STATE OF MAINE
DEPARTMENT OF TRANSPORTATION
16 STATE HOUSE STATION
AUGUSTA, MAINE
04333-0016

October 17, 2006
Subject: **Calais-St. Stephens**
Project Number: NCPD/CBI-8483(360)X
PIN: 8483.36
Bid Amendment No. 2

ST. CROIX RIVER BRIDGE
OVER
ST. CROIX RIVER
BETWEEN
ST. STEPHEN, N.B., CANADA
CALAIS, MAINE, U.S.A.

PRECAST GIRDERS

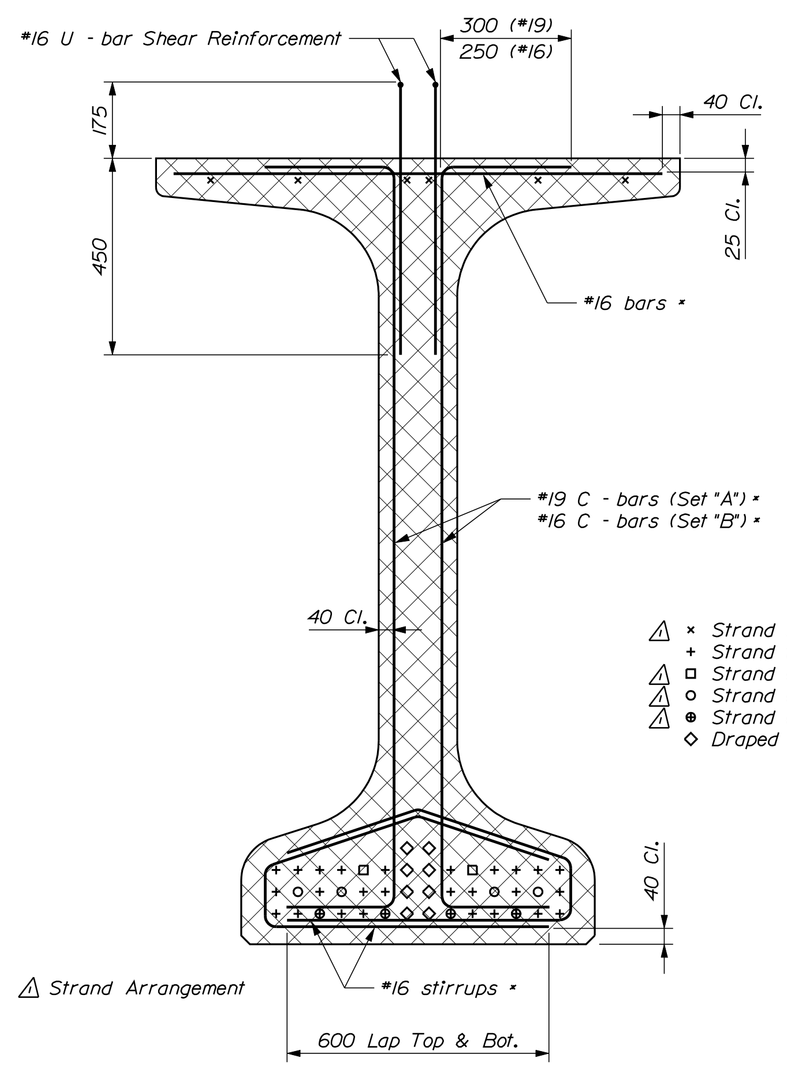
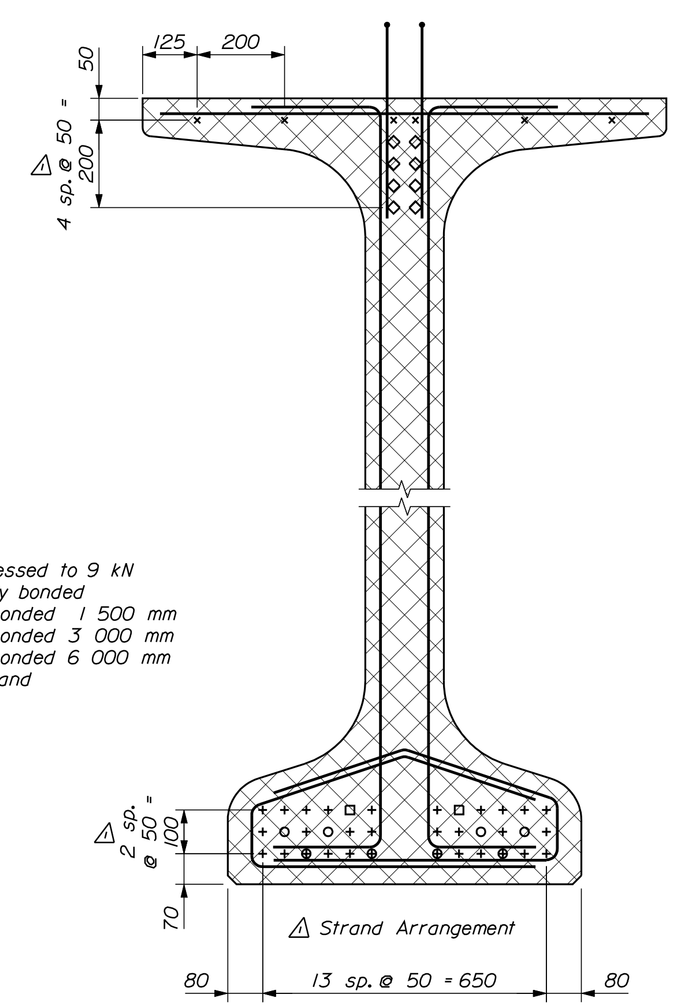
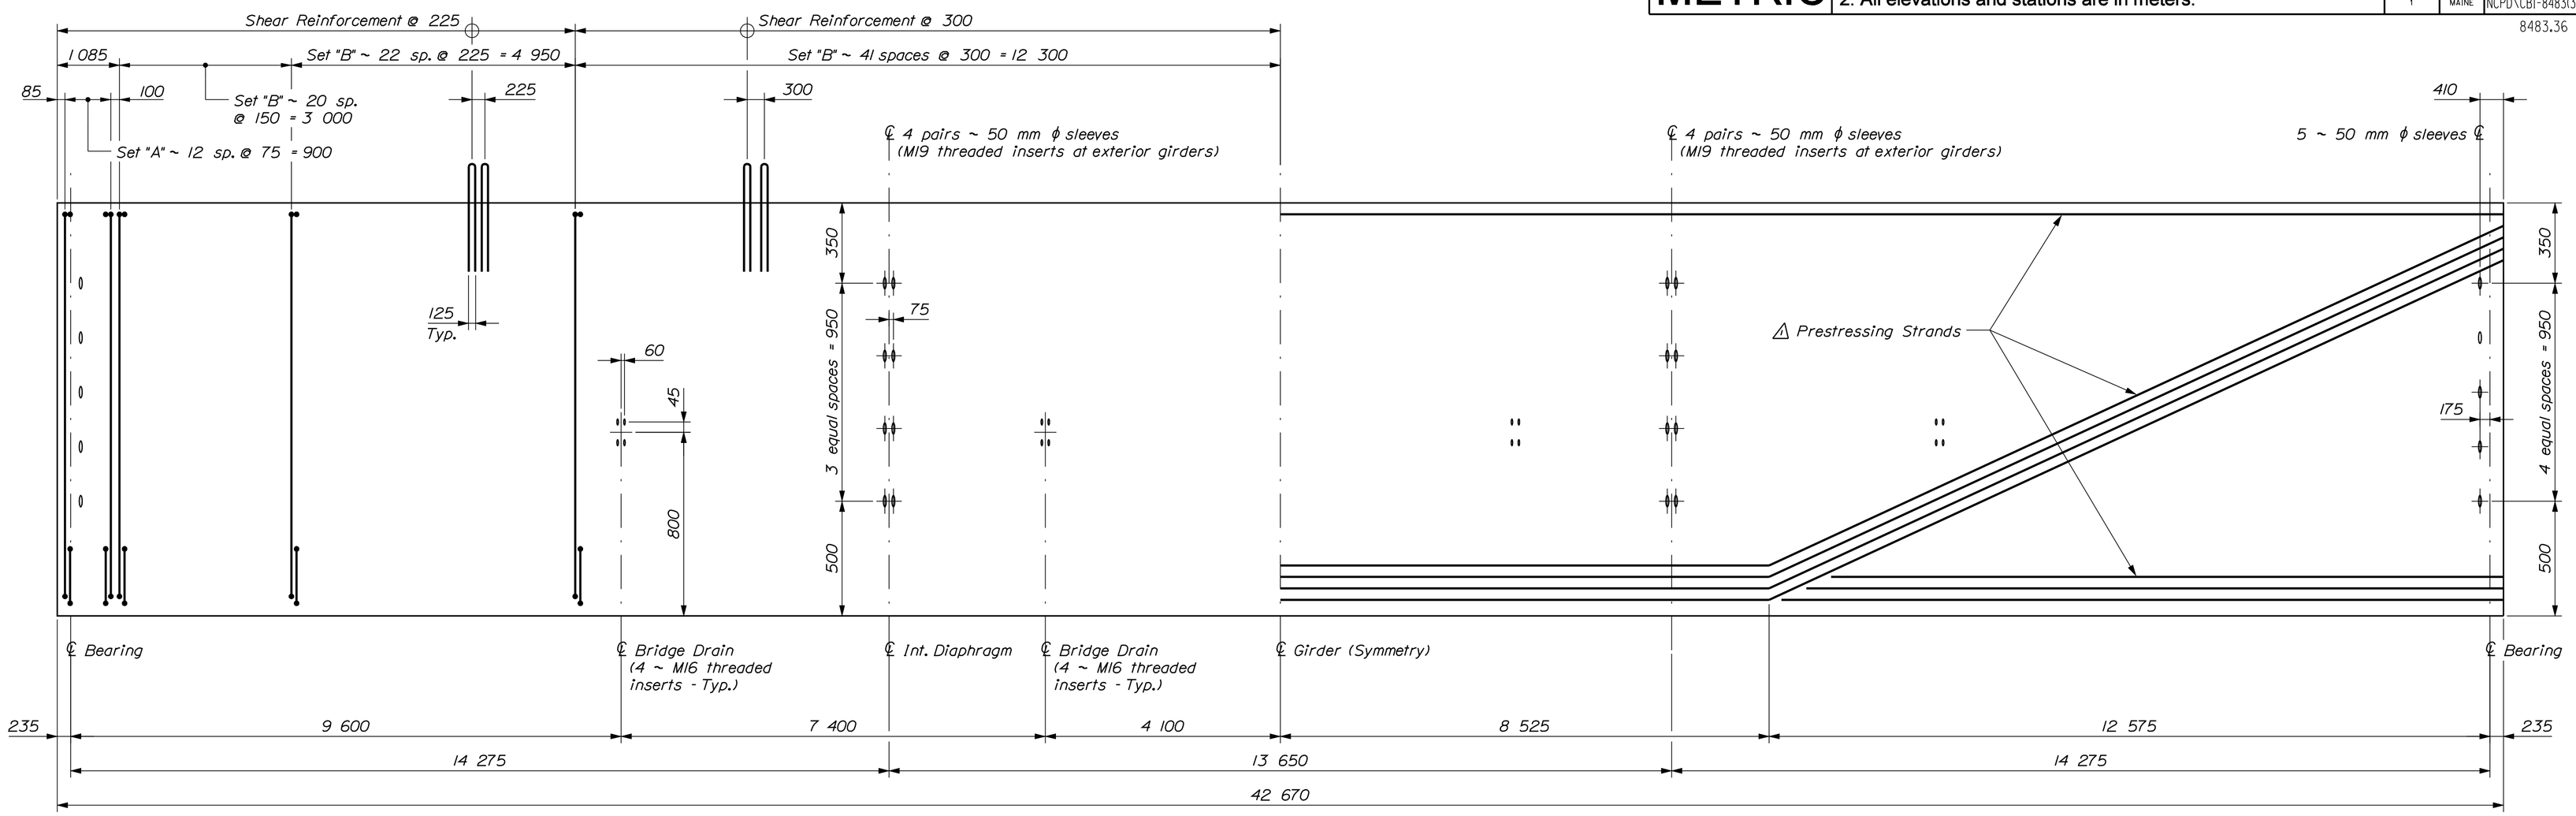
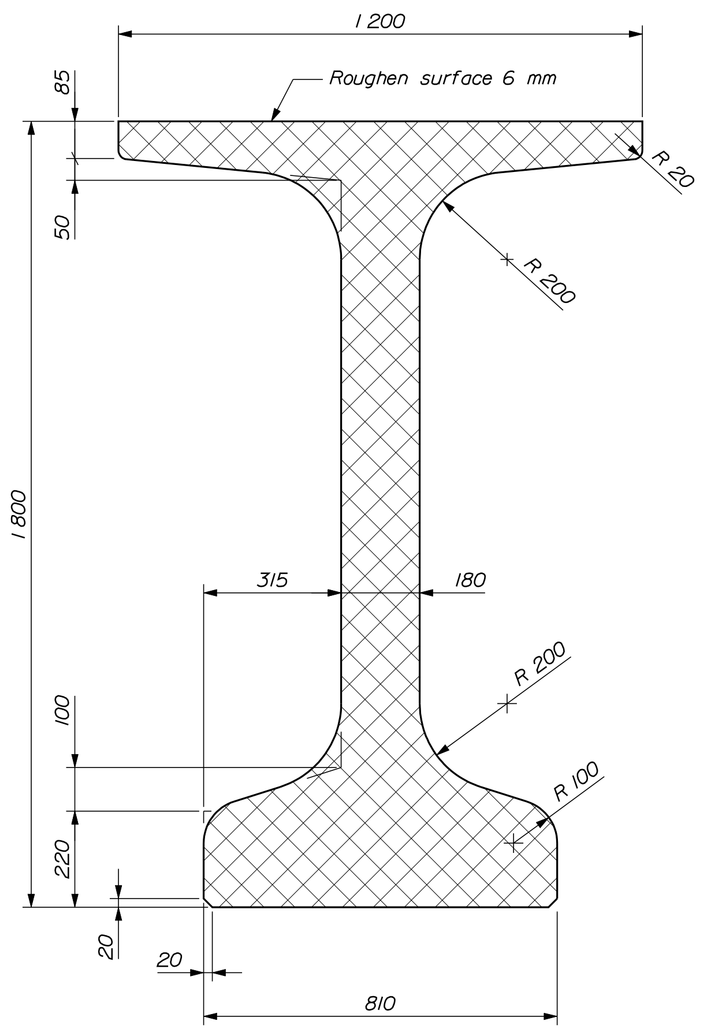
Question: Pre-stressing strand size, location and Quantity?

Response: *The number of pre-stressing strands has been reduced to 44. Eight strands shall be draped and the remaining 36 will form 3 rows of 12 strands. All strands shall be 15.24 mm (0.6 in) diameter, Low Relaxation 1861 MPa (270 ksi) strands. The strands shall be pulled to 0.75 fpu (1396 MPa, 202.5 ksi). Four strands from the first layer (bottom most) shall be debonded 6 meters. Four strands from the second layer shall be debonded 3 meters. Two strands from the third layer shall be debonded 1.5 meters.*

The top 6 straight strands shall be pulled to only 9 kN (2 kips) to maintain a straight profile along the length of the girder.

Please see new plan sheet 32 of 47 as addressed in this amendment.

△1 × Strand stressed to 9 kN
+ Strand fully bonded
△1 □ Strand debonded 1 500 mm
△1 ○ Strand debonded 3 000 mm
△1 ⊕ Strand debonded 6 000 mm
◇ Draped strand

GIRDER UTILITY INSERTS

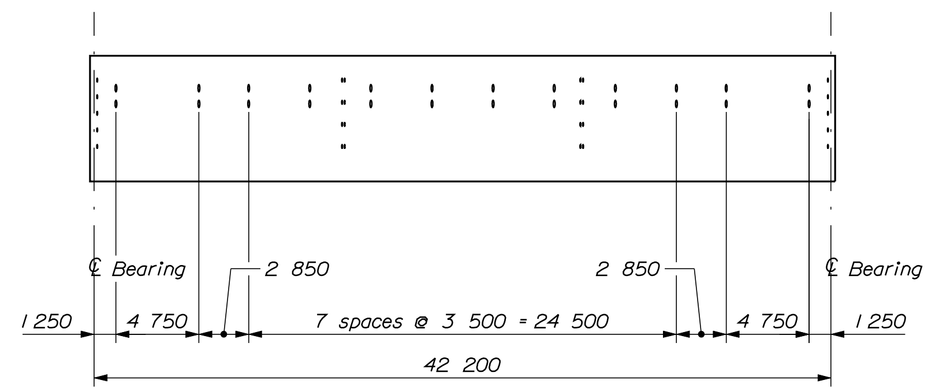
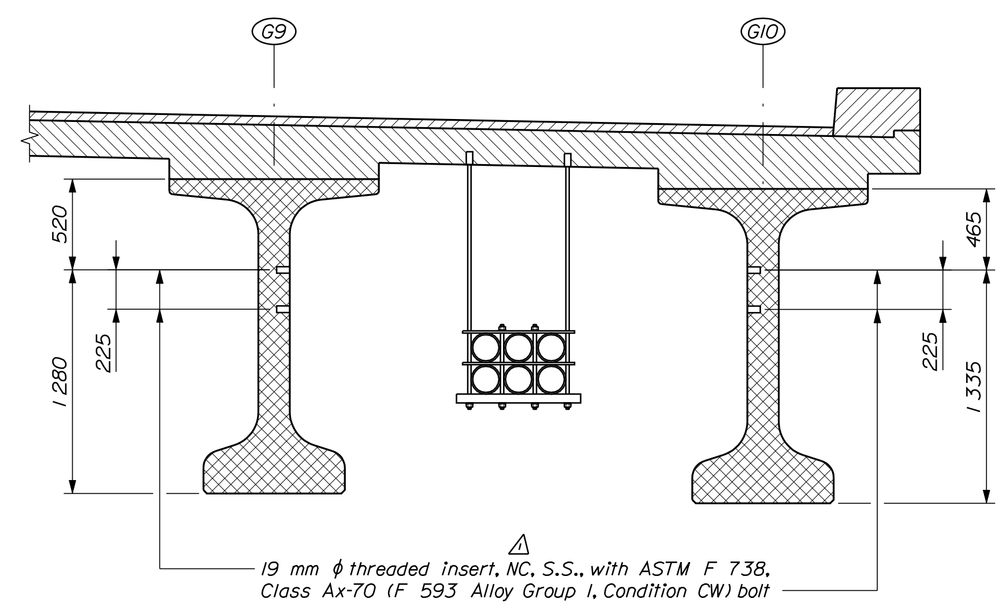
Question: Steel insert and bolt type for Horizontal inserts in Precast Girders.

Response: *All horizontal inserts in the Precast Girder for future utility needs shall be Stainless steel and provided with a stainless steel bolt. The bolt shall meet the requirements of ASTM F738 Class Ax-70 (F593 Alloy Group 1 Condition CW).*

ABUTMENT DIAPHRAGMS

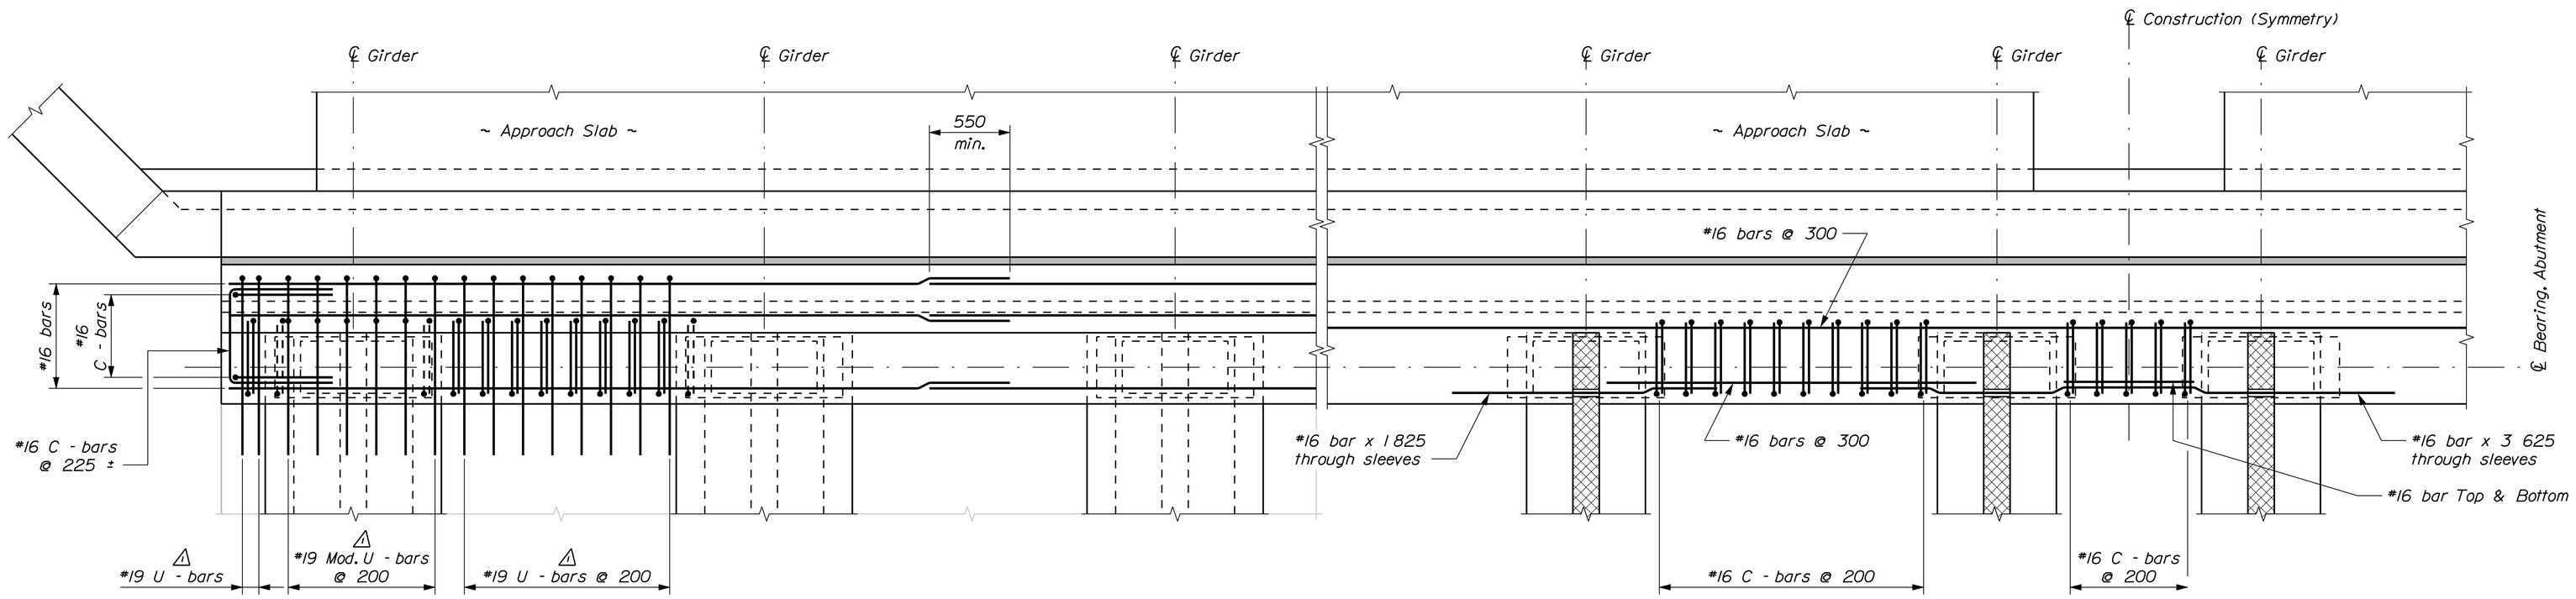
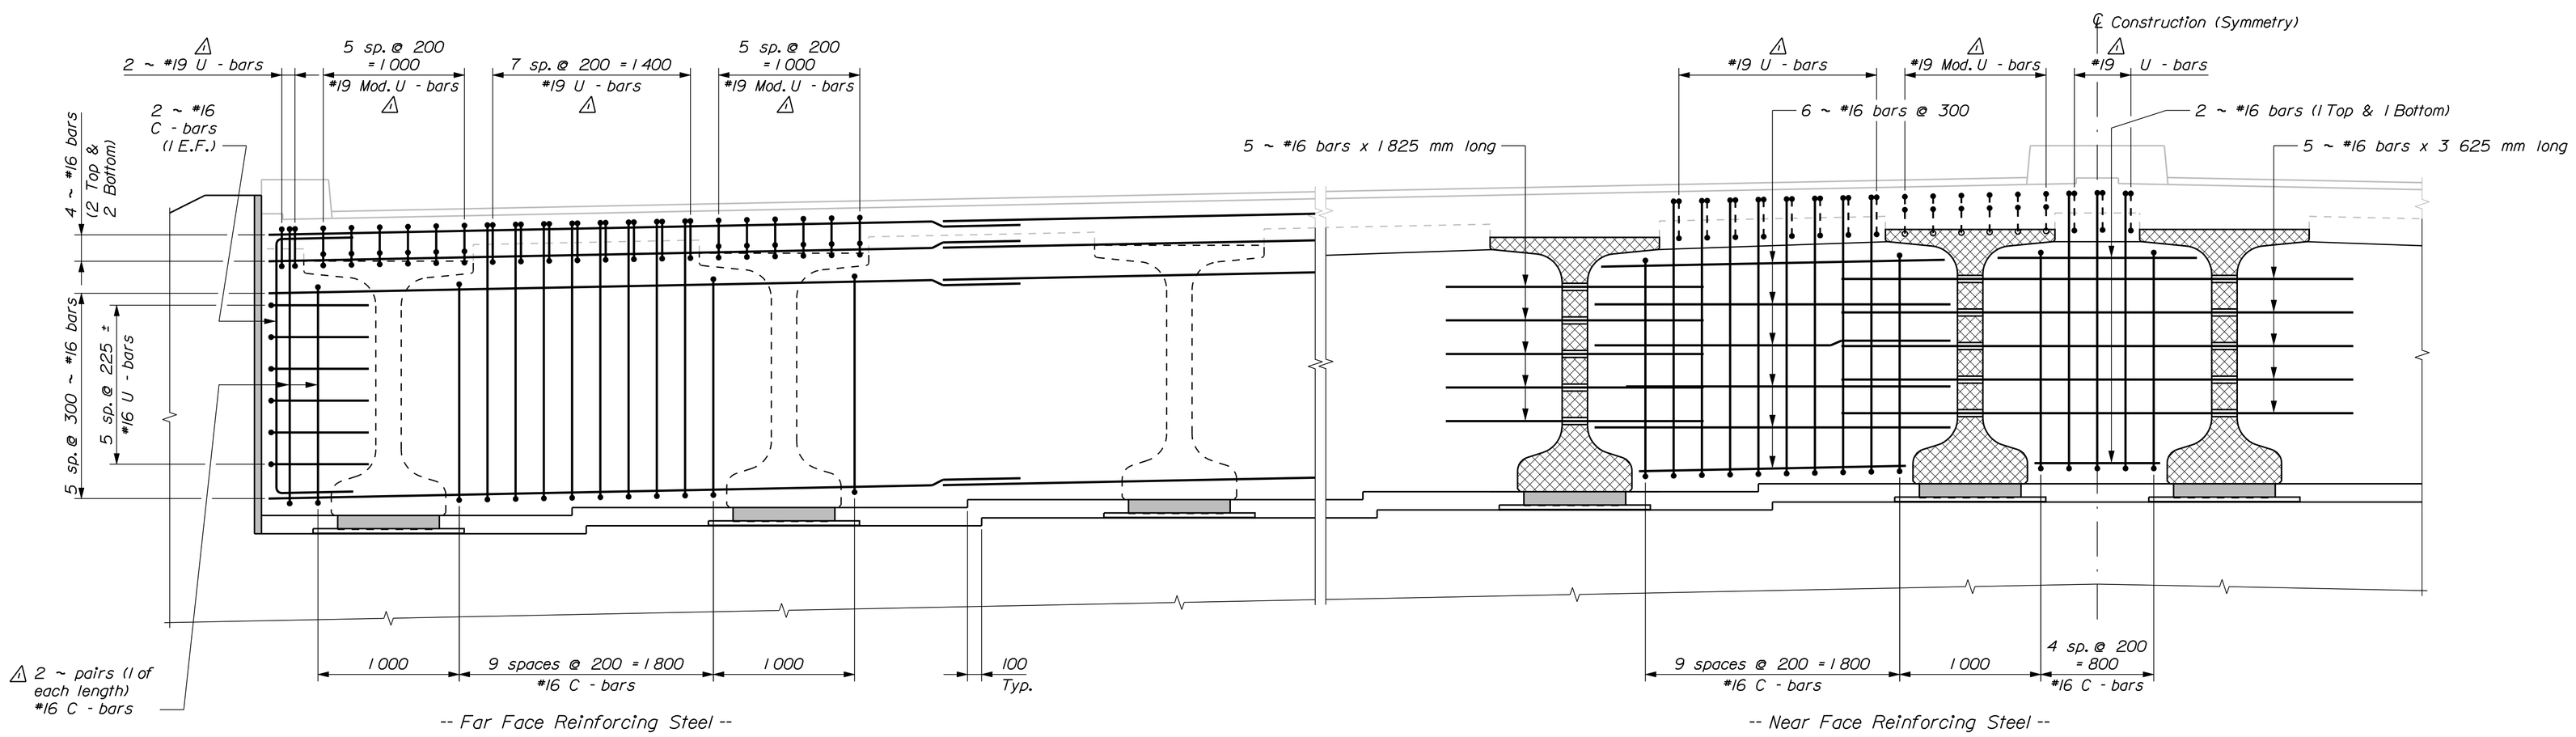
Question: Abutment Diaphragm sheets 34 and 35 of 47; clarify U bars and Modified U bars. Are they #16 or #19? Is Rebar for Transition barrier MMFX2?

Response: *All U bars and modified U bars in the overhang section of the deck shall be #19 bars. Rebar for Transition Barriers shall also be MMFX2.*
